Mask Set Errata for Mask 3K45H

This mask set errata applies to the mask 3K45H for these products:

- MC68HC908JB8

SE115-Power

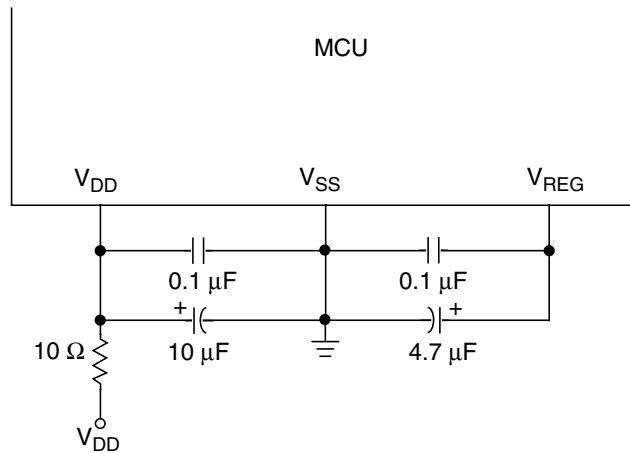
A few devices start abnormally during power-up. The issue is the release of the low voltage reset (LVR) earlier than the V_{REG} reaching the CMOS logic operating voltage (typical 0.65 V).

The LVR takes the V_{DD} but not the V_{REG} as a reference. LVR exists until the V_{DD} reaches the LVR threshold voltage (V_{LVR}). The problem happens in few devices when the V_{DD} rises quickly and the V_{REG} rises slowly. If the LVR has been released but the V_{REG} doesn't reach the CMOS logic operating voltage, the LVR does not have any effect. This might cause the internal logic to improperly initialize and the MCU might not start normally.

Therefore, the V_{DD} voltage must be lower than the VLVR minimum (2.8 V) when the V_{REG} voltage reaches the CMOS logic operating voltage.

To fix the problem, add a 10 Ω series resistor between the power supply and the V_{DD} , and place a 10 μF capacitor at the V_{DD} pin and a 4.7 μF capacitor at the V_{REG} pin.

SE30-PWM

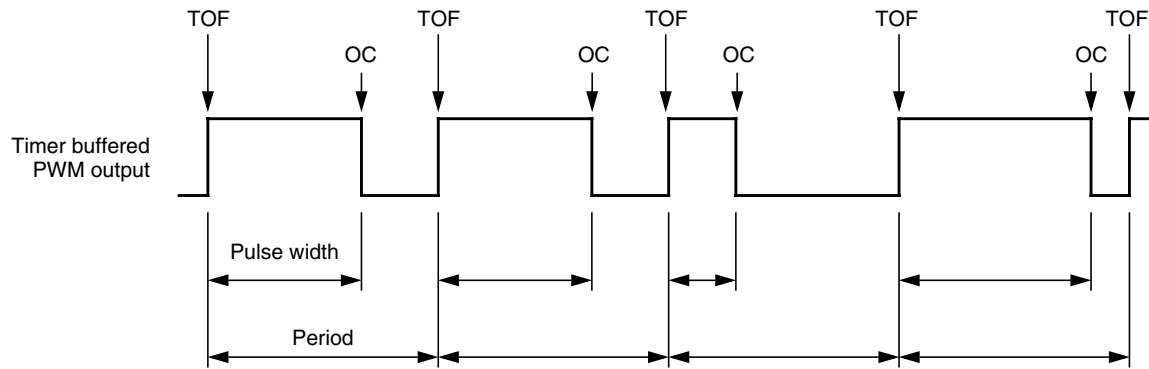
In timer buffered PWM operation, when a timer overflow (TOF) event or an output compare (OC) event coincides with a write to either pair of the timer channel registers (TCHxH/L), the duty cycle at the PWM output glitches to 0% or 100% momentarily, then returns to proper operation.

To avoid the glitches when changing the PWM duty cycle, do not write to either pair of the timer channel registers at the TOF or OC.

For example, in the TOF interrupt service routine: If the OC occurs near the last TOF, write to the timer channel registers after the OC; if the OC occurs near the next TOF, write to the timer channel registers before the OC. A write to the channel register high byte (TCHxH) should immediately followed by a write to the low byte (TCHxL) to avoid TOF or OC occurring between the writes. Instruction cycle times must be included when making timing calculations.
